Tender PZA170421T-10056- Questions and answers

v. 12/06/2023

PROJECT TITLE:
Al-Sheikh Saad Girls School
External Works

Ahmed Tomizeh

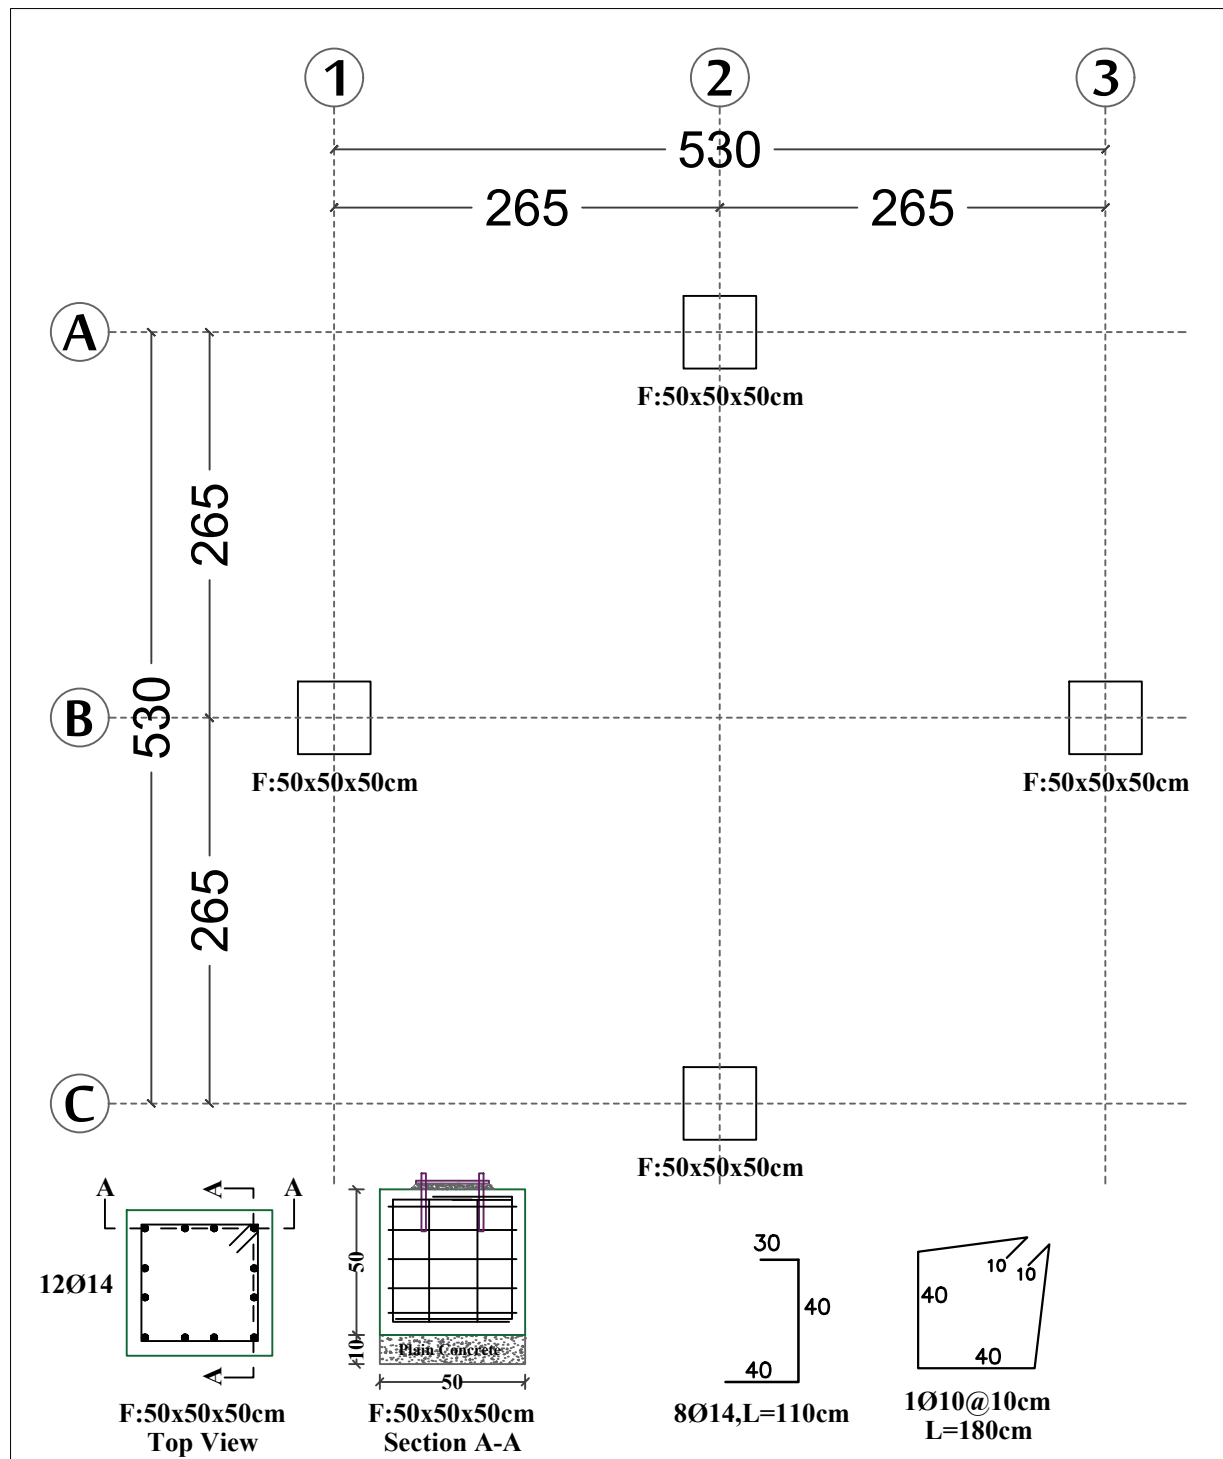
Question 8: Regarding wall section (3-3) on the upper side, will it be replacing the existing wall, or will it be constructed adjacent to the wall location?

ERRATUM#3: *Please refer to attachment# 1 for modified wall section (3-3) which shall be constructed adjacent the existing wall.*

Steel Structure Layout

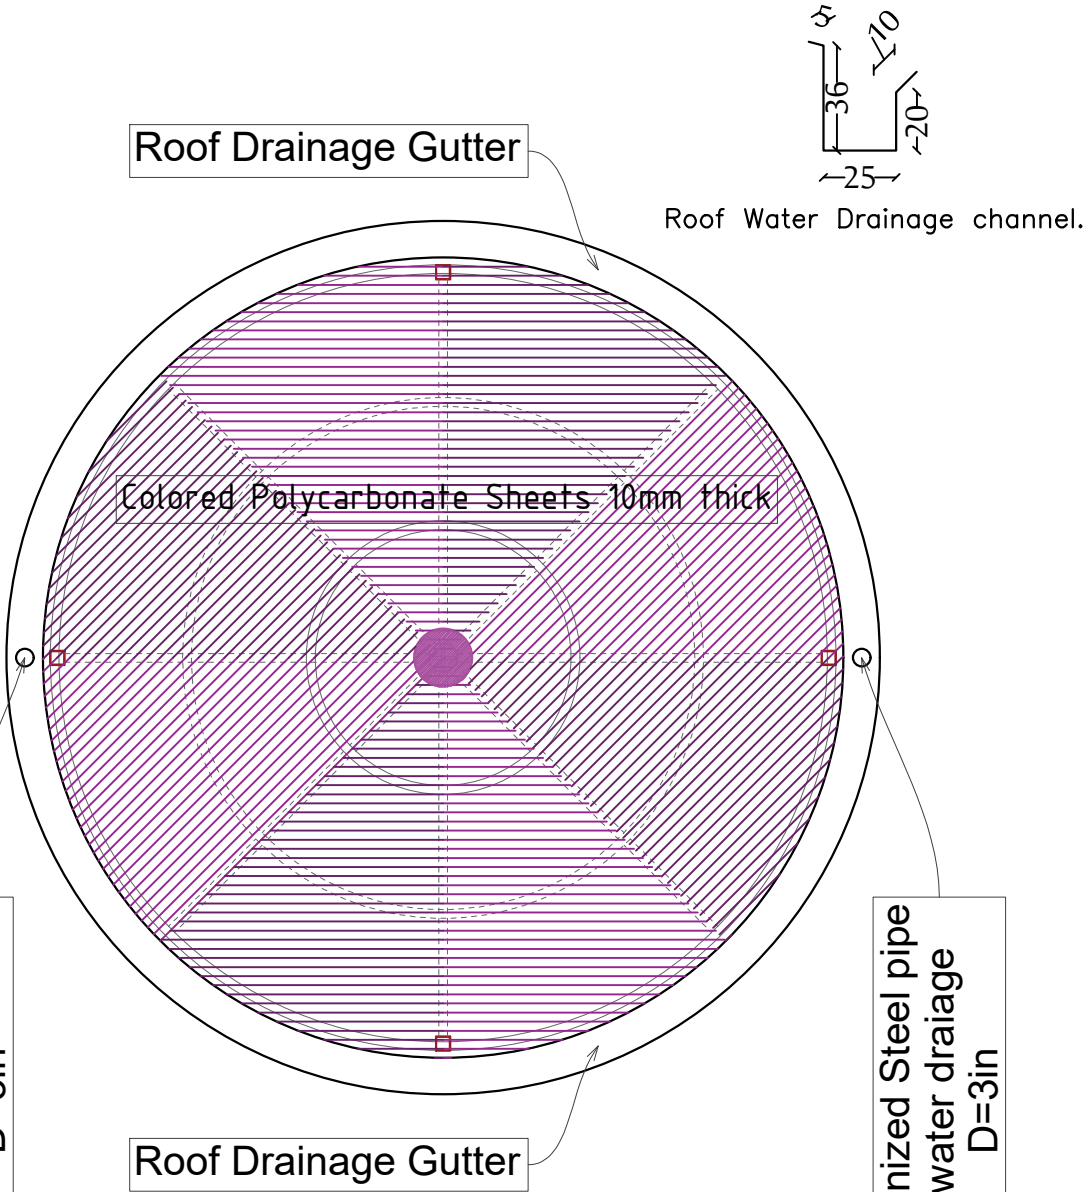
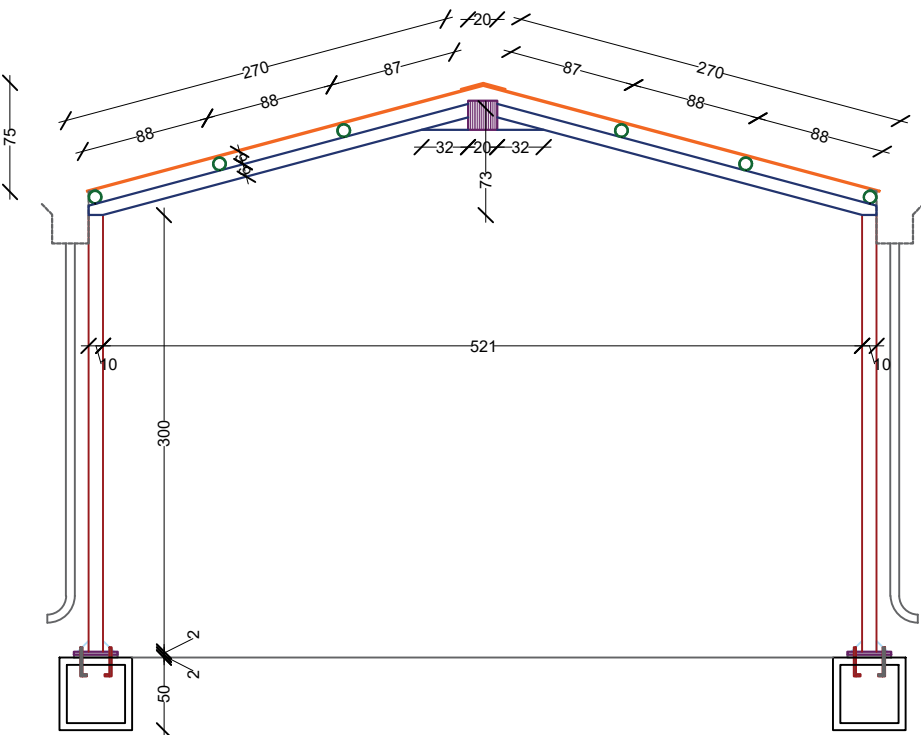
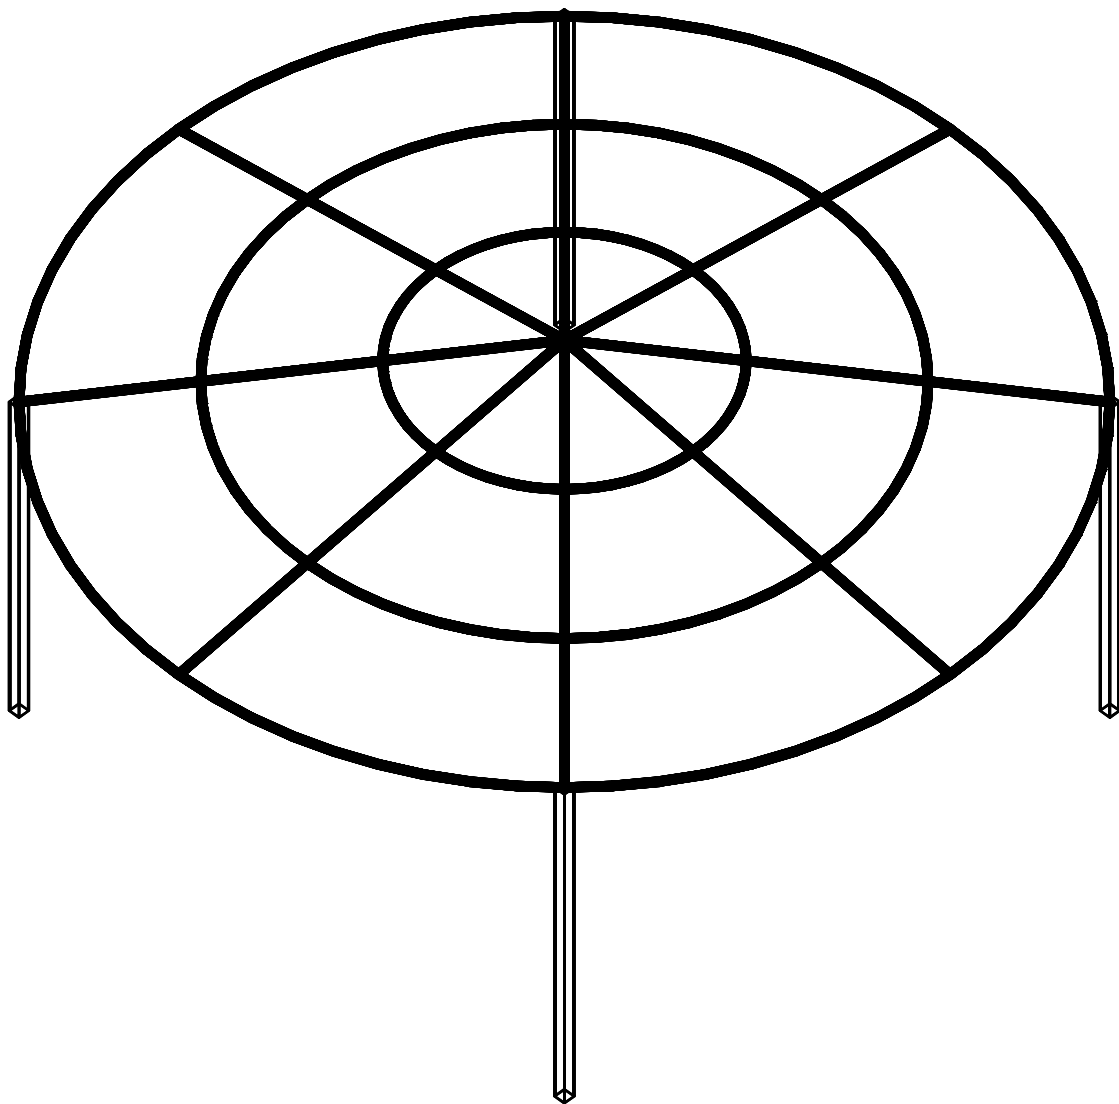
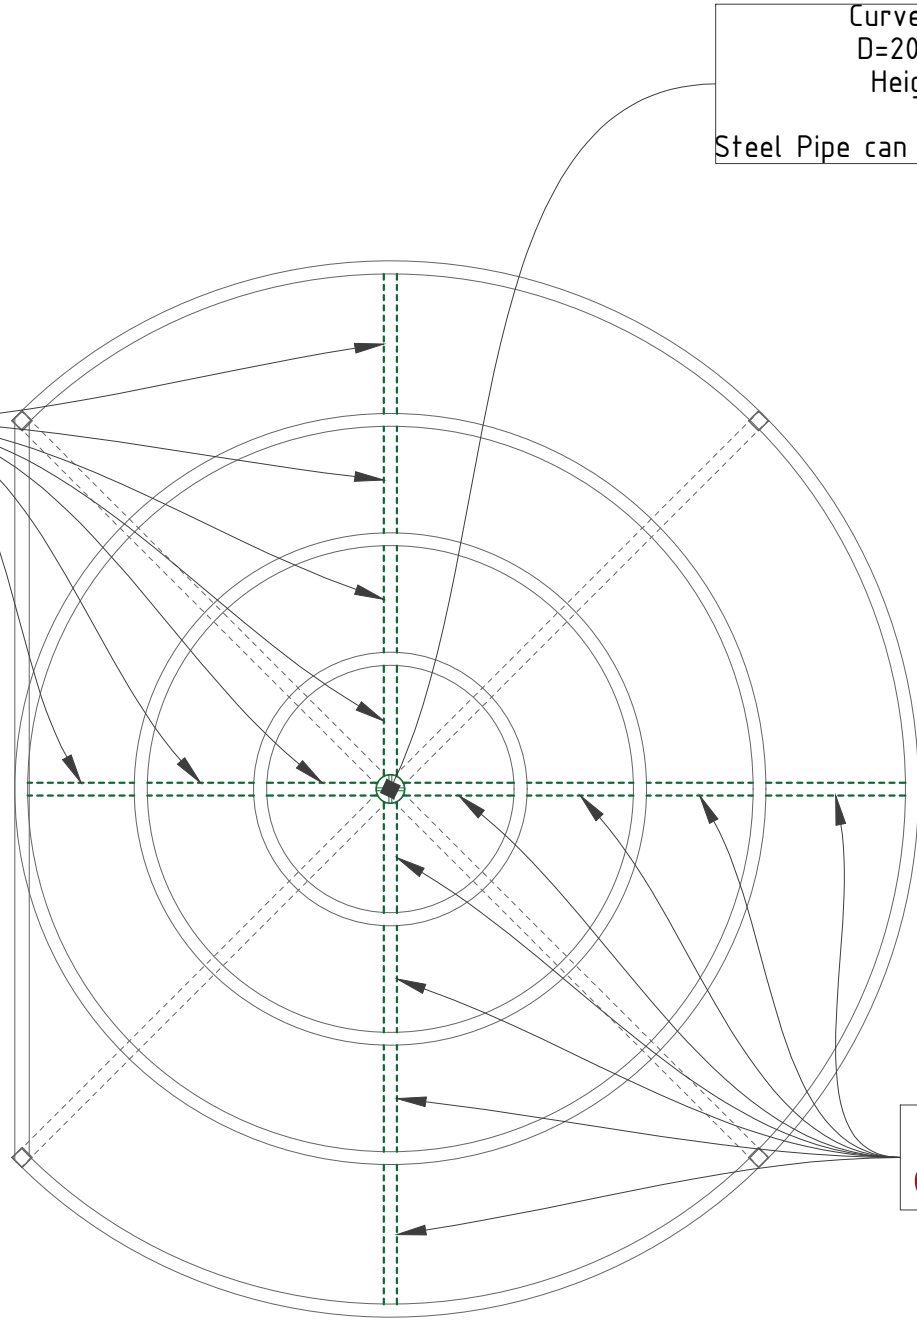
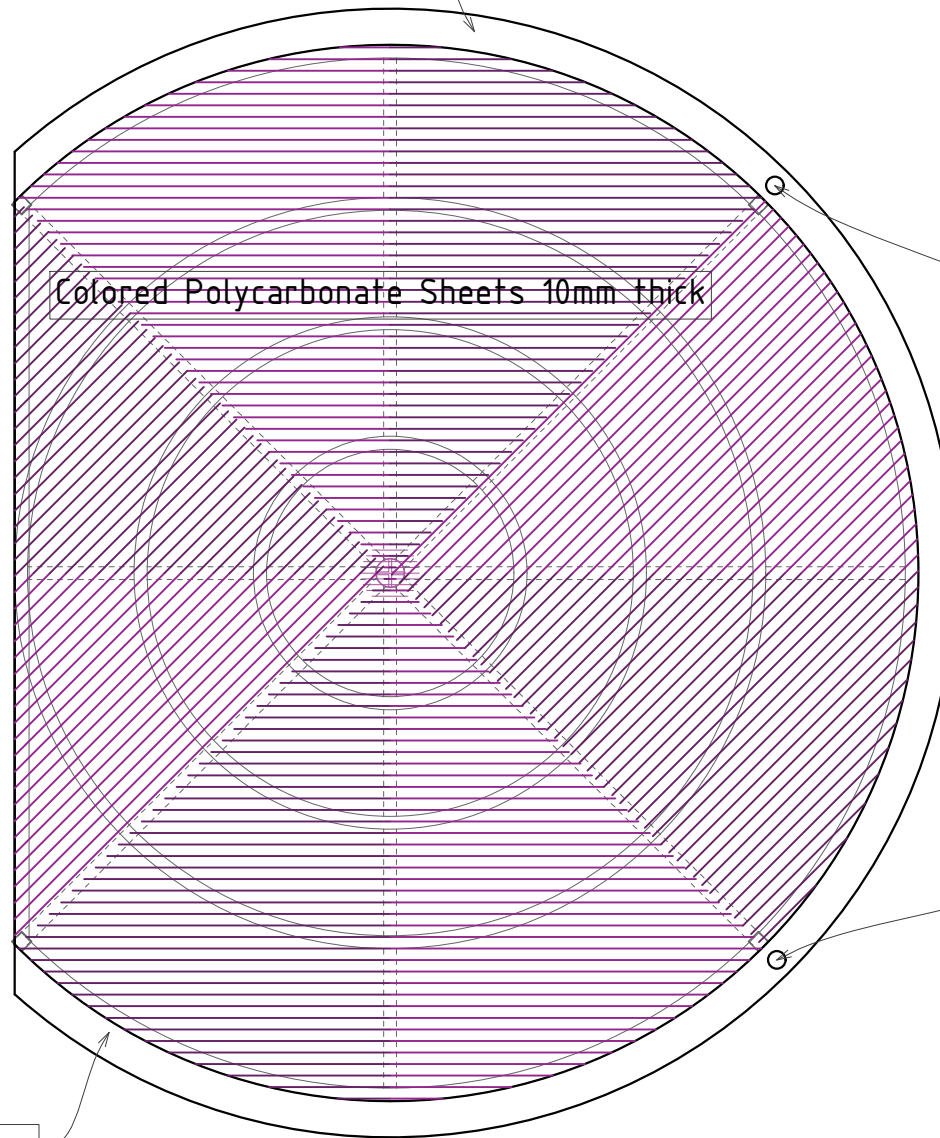
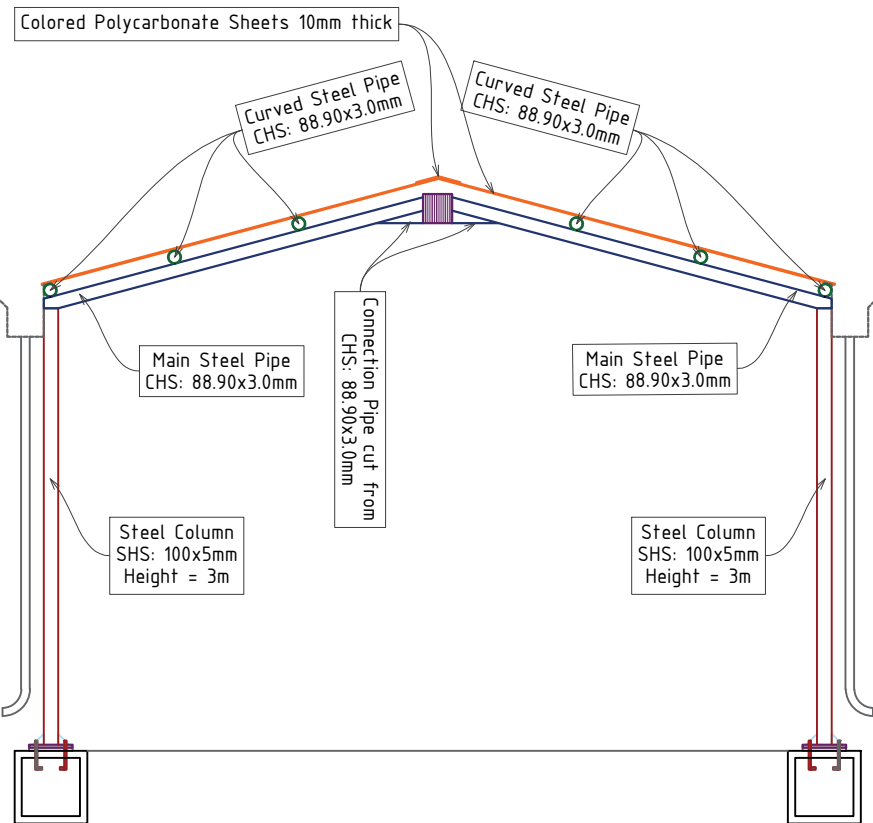
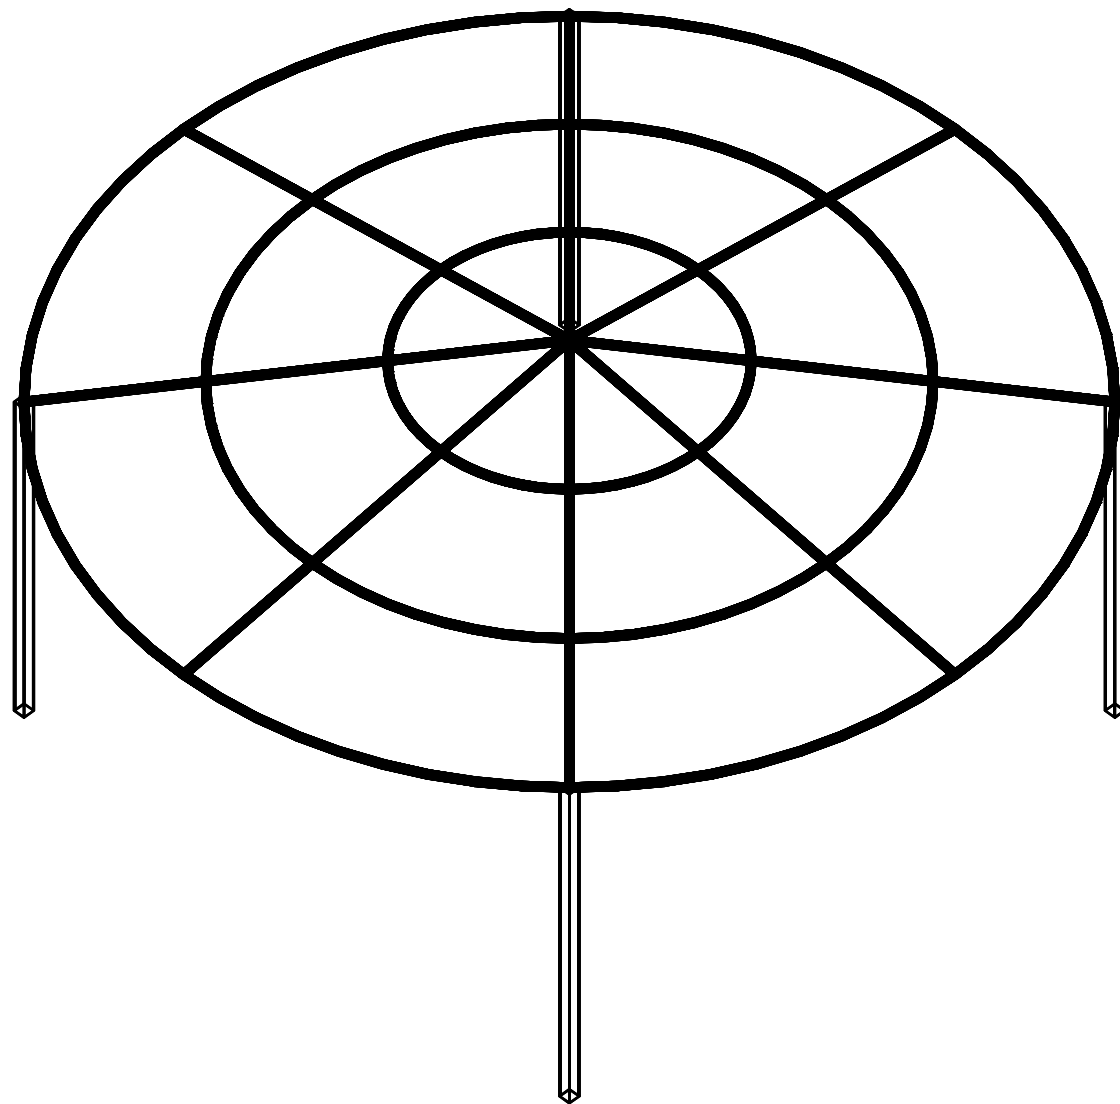
Question 10: Missing details of Circular shade for the kindergarten as per item no 12.31.

ERRATUM#4: *Please refer attachment# 2 for circular shade at kindergarten.*
